DEVELOPMENT ADVISORY PANEL – TUESDAY 28 MARCH 2023 AT 2PM

Property: LOT: 11 DP: 593328, LOT: 14 DP: 792128, 60 Bangalow Road BYRON BAY, LOT: 1 DP: 525896, 58 Bangalow Road BYRON BAY NSW 2481

The applicant proposes twenty-four (24) two level affordable (Worker Housing) dwelling units, 30 internal car parks spaces excluding 4 parks designed for the external council road stub, appropriate internal vehicle manoeuvring space, communal space and rubbish bin storage etc. as per the plans below:

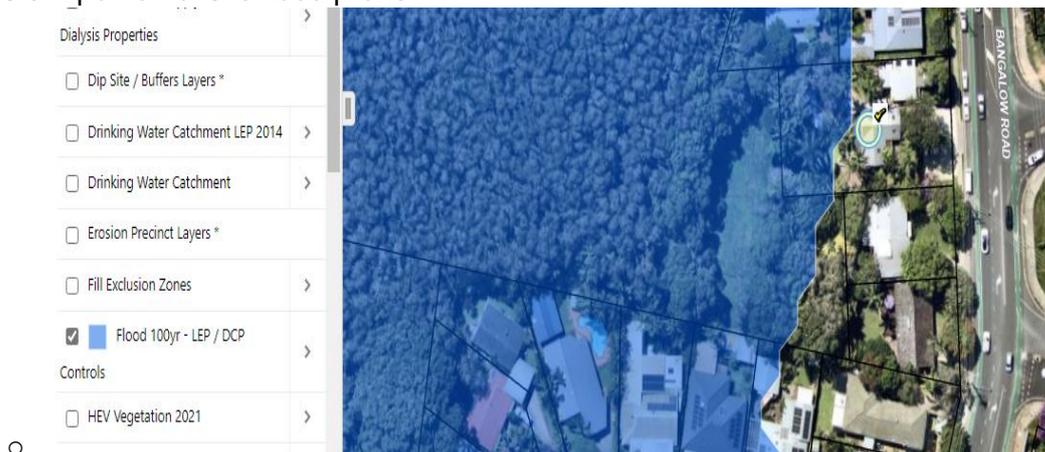
We have assumed a 20m APZ from the line of native tree vegetation and a 29BAL design for bushfire protection. Overall we plan to improve the ability to fight fire for all the surrounding properties.

The depth of the APZ and BAL response proposed will be established by the applicant's ecologist, fire engineer, stormwater engineer and planner working together. Council will assess the resultant proposal in a similarly coordinated manner.
